# **Environmental Impact Statement for the License Renewal of the Columbia Fuel Fabrication Facility in Richland County, South Carolina**

Final Report

**Figure 2-4 CFFF Operational Units (Source: Modified from Google Earth)**

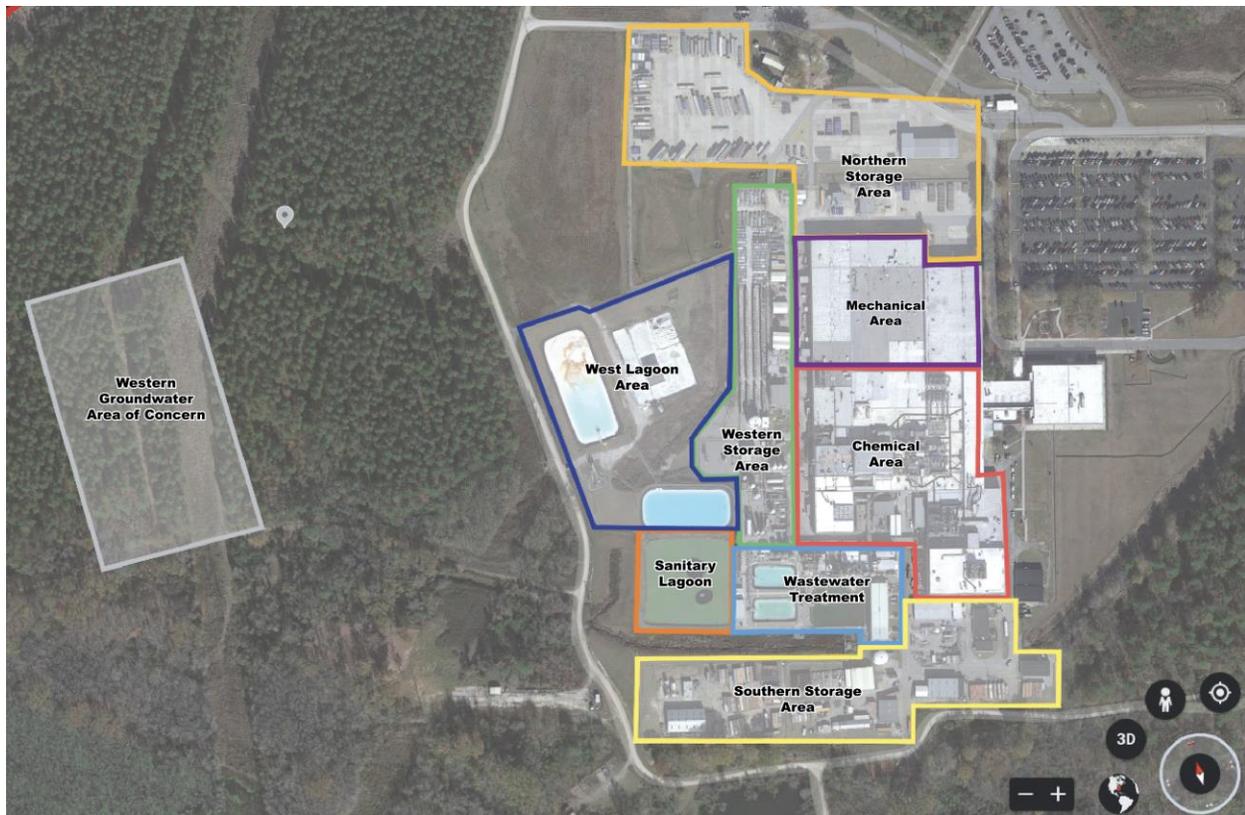
Current Wording: "Figure 2-4 shows the location of the six onsite lagoon storage basins in the West Lagoons Area, Wastewater Treatment Area, and Sanitary Lagoon Area."

Suggested Wording: "Figure 2-4 shows the location of the ~~six~~ **five remaining** onsite lagoons and the former location of the East Lagoon. ~~storage basins in the West Lagoons Area, Wastewater Treatment Area, and Sanitary Lagoon Area.~~"

**Figure 2-7 Sampling Locations for Air, Vegetation, and Soil (Source: WEC 2019-TN6423, with enhancements to label clarity)**

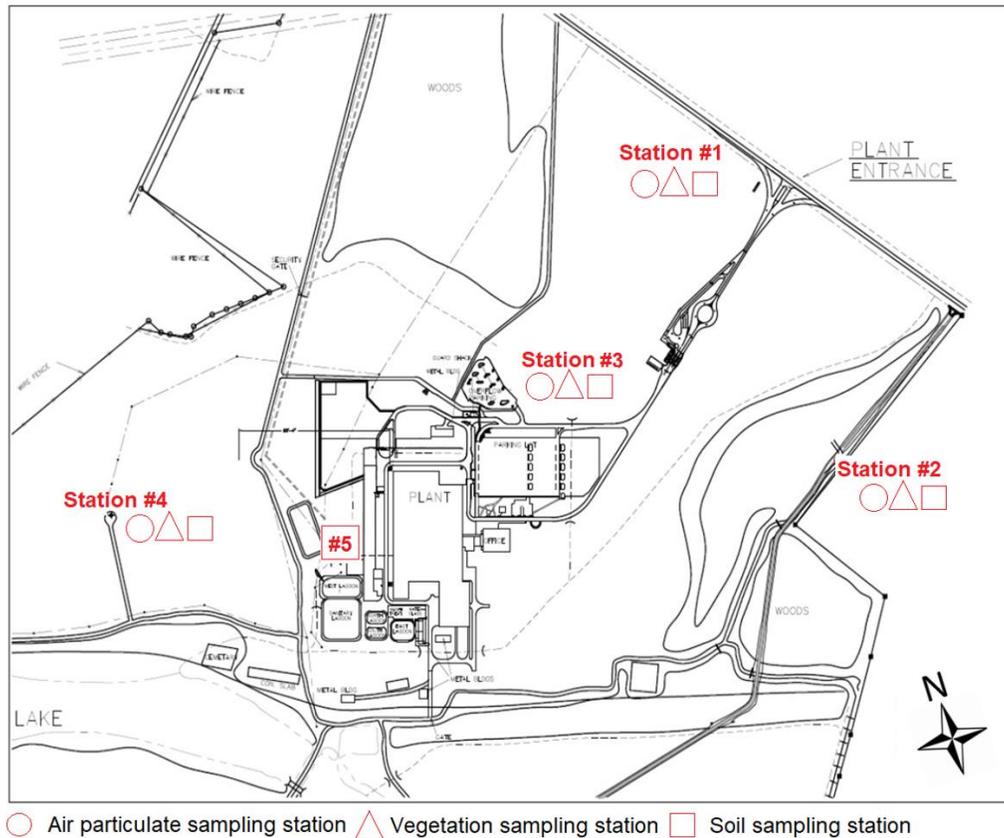
**Comment:** 4. Many of the included maps and figures lack critical elements such as legends and/or scale bars (e.g., Fig 2-1, 2-2, 2-4, 2-7). Fig 2-10, while useful, has no orientation

Figure 2-9 Groundwater Well Locations at the CFFF Site (Source: WEC 2021-TN7170)

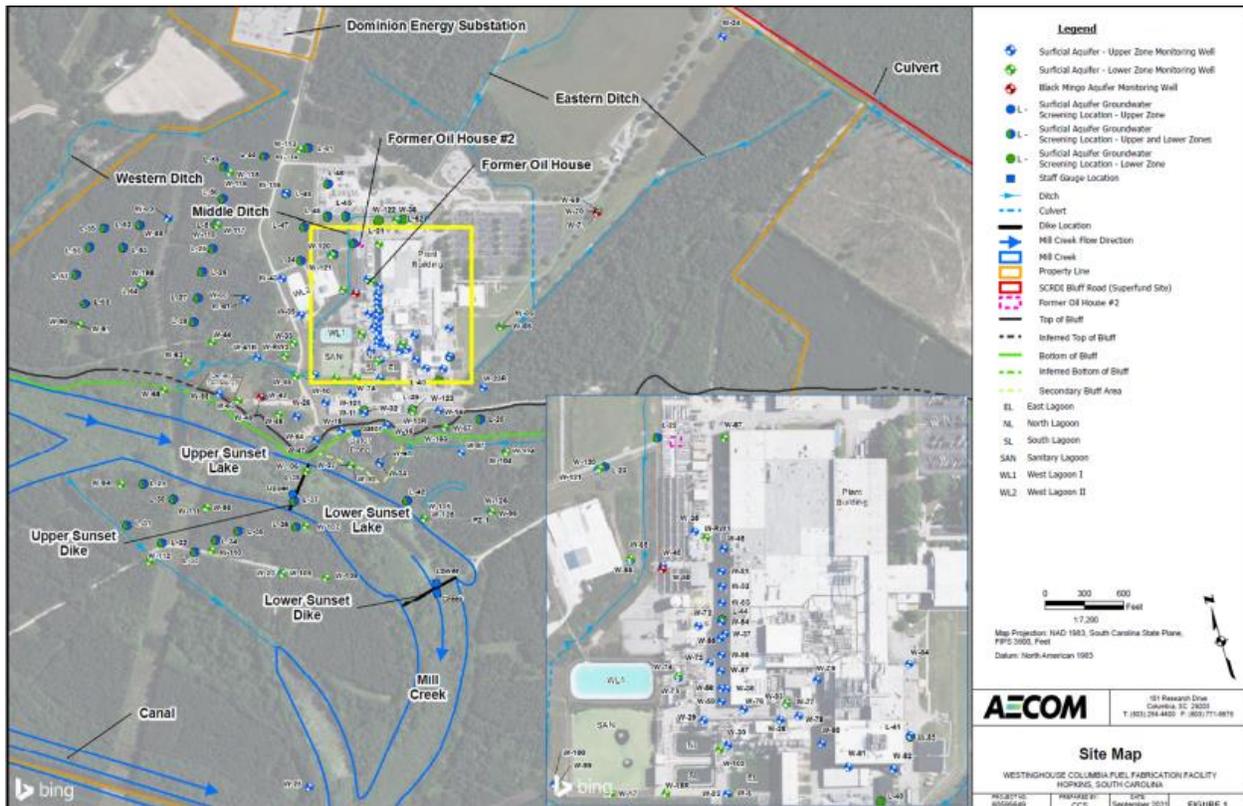
Line: Figure 2-9

Suggested Wording: Suggest replacing Figure 2-9 with Enclosure 4.

**Figure 3-4 Location Map of Earthquake Epicenters for Earthquakes between 1900 and September 1, 2020, for the South Carolina Region (Source: USGS 2021-TN6951). The geographic bounding box for the earthquake search is as follows: Latitude 32.1 – 35.7N and Longitude 79.3-83.5W.**

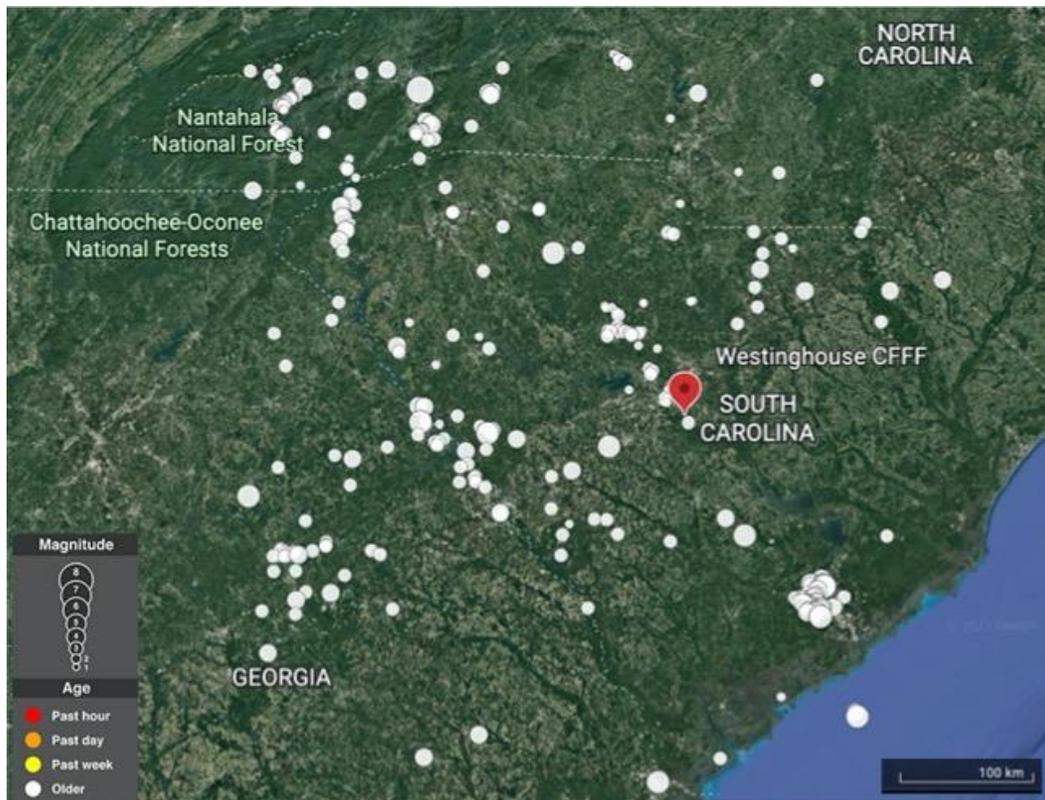
**Comment:** The search area or search radius used for the USGS earthquake catalog is not listed or defined (Lat/Long boxes or similar), nor does the included location map include a scale bar (Fig 3-4). The USGS peak acceleration map cited in the text could be helpful, especially if it was cropped to the region in question and the CFFF site located. The current map could be combined with the earthquake epicenters plotted. The earthquake magnitude distribution has

**Response:** *The NRC staff will revise Section 3.2.3 of the EIS to provide additional clarity and detail as requested by the commenter, including the revision of Figure 3-4.*

**Figure 3-11 Gross Beta in Gator Pond Water Samples (Source: WEC 2019-TN6571 WEC 2021-TN7110)**

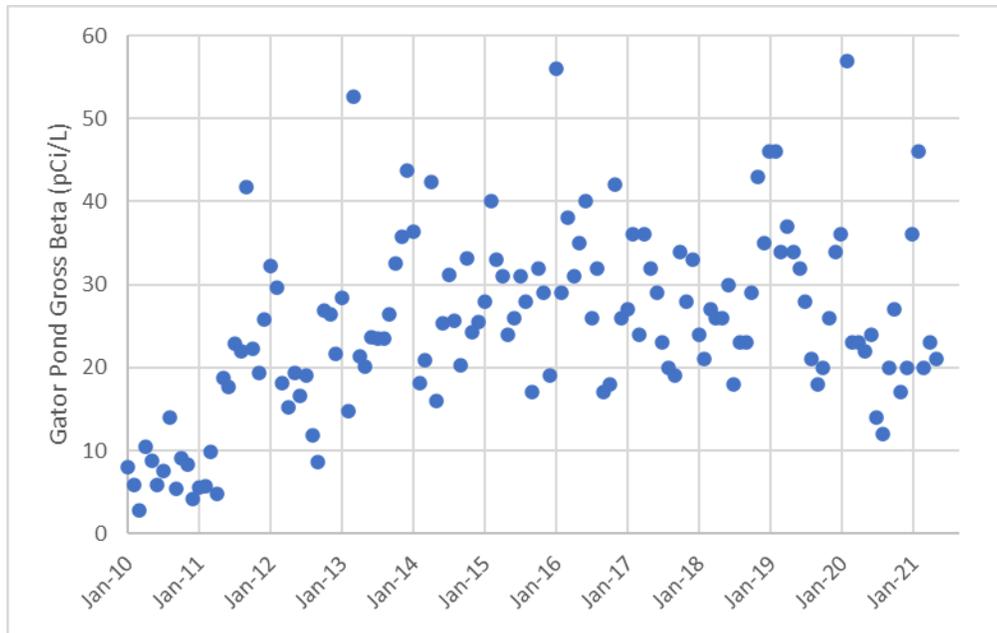
**Comment:** The DEIS section 3.4.1.2.2 "Gross Beta and Technicium-99" needs to discuss the historical source of Tc-99 from previous decades, and why gross beta counts at Gator Pond (i.e., Fig 3-11) are basically constant over time after an initial short increasing trend around 2010 and not decreasing afterward. We recommend that the Final EIS provide a more in-depth discussion regarding the history of Tc-99 at Gator Pond. (34-2-13 [Fite, Mark])

**Figure 3-15 PCE Concentrations in the Surficial Aquifer (for reference, the PCE MCL is 5 µg/L). The AS/SVE System Operated from 1998 to 2010 (Sources: AECOM 2013-TN5508, AECOM 2017-TN5512; WEC 2019-TN6510, WEC 2020-TN6526, WEC 2020-TN6875)**

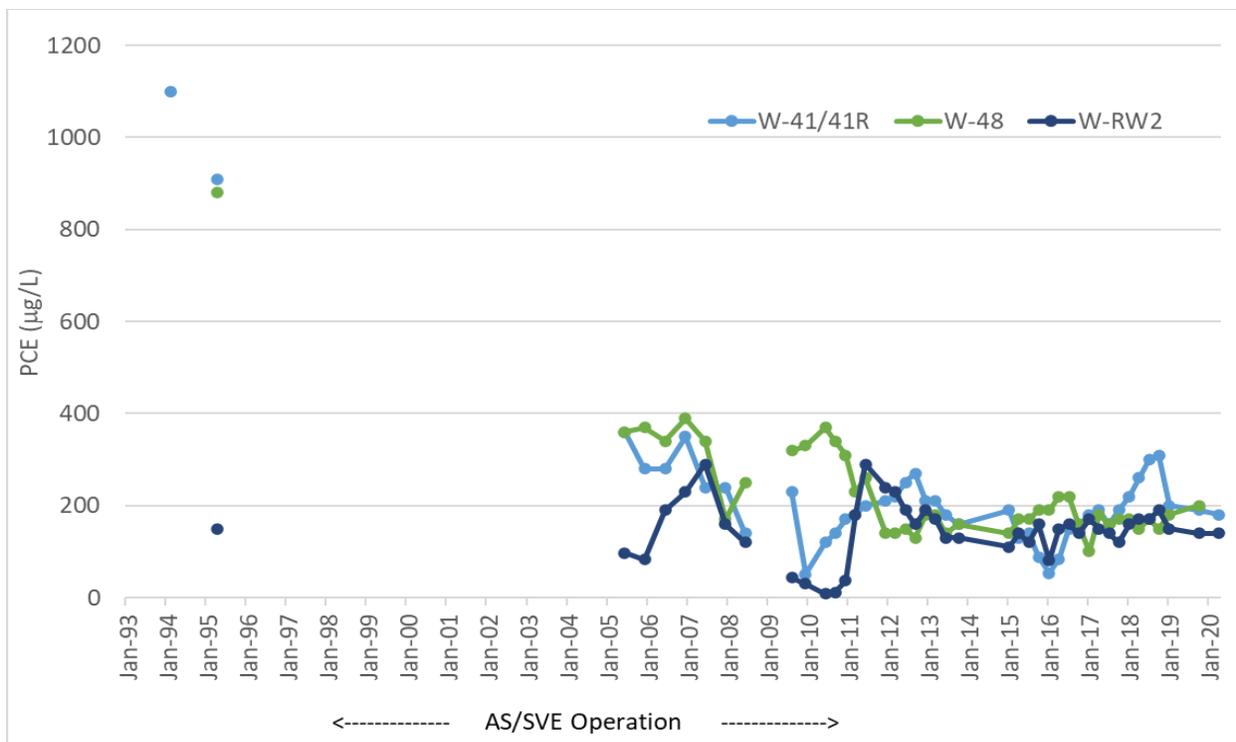
Current Wording: Figure 3-14 PCE Concentrations in the Surficial Aquifer

Justification: Since 2004, CFFF has consistently monitoring VOCs in four site wells (W-26, W-41R, W-48, and W-RW2) as required by the site's NPDES permit issued by SCDHEC. Figure 3-14 excludes data for W-26. The correct well designation is W-41R.

**Figure 3-18** Gross Beta (open circles) and Tc-99 (filled circles) Activity at the Well Pair W-32 (red) and W-11 (blue) (Source: WEC 2020-TN6875, WEC 2021-TN7112, WEC 2022-TN7155)

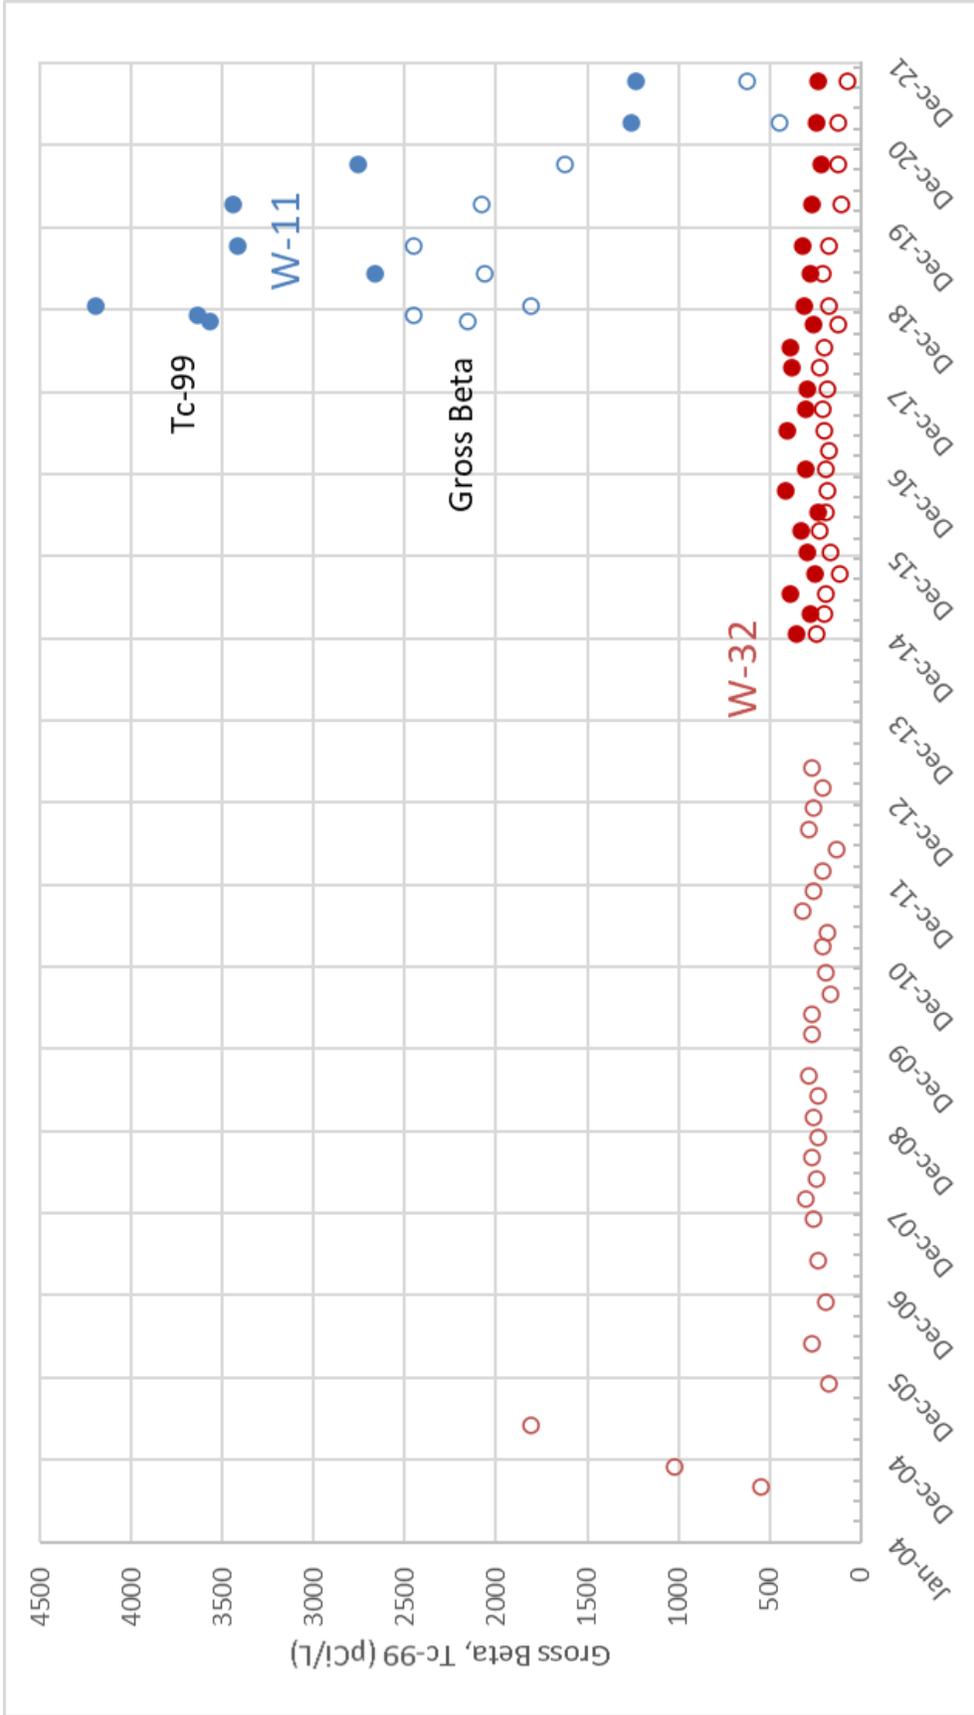
Current Wording: "Figure 3-17 Gross Beta (open circles) and Tc-99 (filled circles) Activity at the Well Pair W-32 (red) and W-6 (blue) (Source: WEC 2020-TN6875)."

Suggested Wording: "Figure 3-17 Gross Beta (open circles) and Tc-99 (filled circles) Activity at the Well Pair W-32 (red) and W-~~6~~**11** (blue) (Source: WEC 2020-TN6875)."
